CITY OF ALBUQUERQUE

**RE: First Christian Church, 10101 Montgomery Blvd.
Grading and Drainage Plan
Engineer's Stamp Date 4-01-2015 (File: F21-D080)**

DRAINAGE AND TRANSPORTATION INFORMATION SHEET

RE: First Christian Church, 10101 Montgomery Boulevard NE
Grading and Drainage Plan (F21-D080)

FIRST CHRISTIAN CHURCH	DRAWN BY DEM
		DATE J-2015
RICHARD H. DOURTE P.E. # 10854	GRADING & DRAINAGE PLAN CITY OF ALBUQUERQUE	FINAL CHURCH BUILDING
		SHEET # 4 of 6
		JOB # X000X

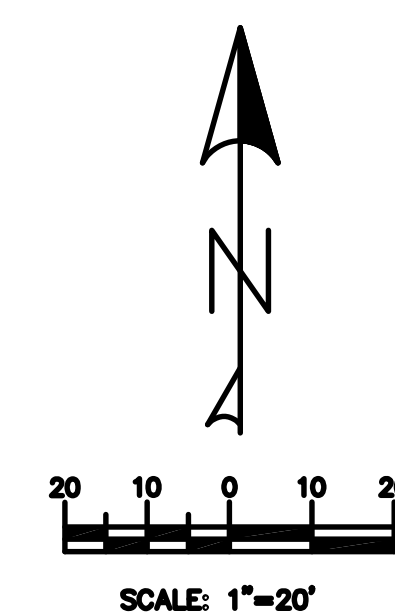
1. The new improvement area that are contributing to the 0.13 ac area you referenced are included on the attached document. Elevation information is included on the grading plan.
2. The information requested in included on the attached document or on the grading plan.
3. The elevations have been corrected on the grading plan.
4. The sidewalk has been labeled, std dwg drawing has been called out and the detail for the pipe outlet and culvert have been added to the grading plan.
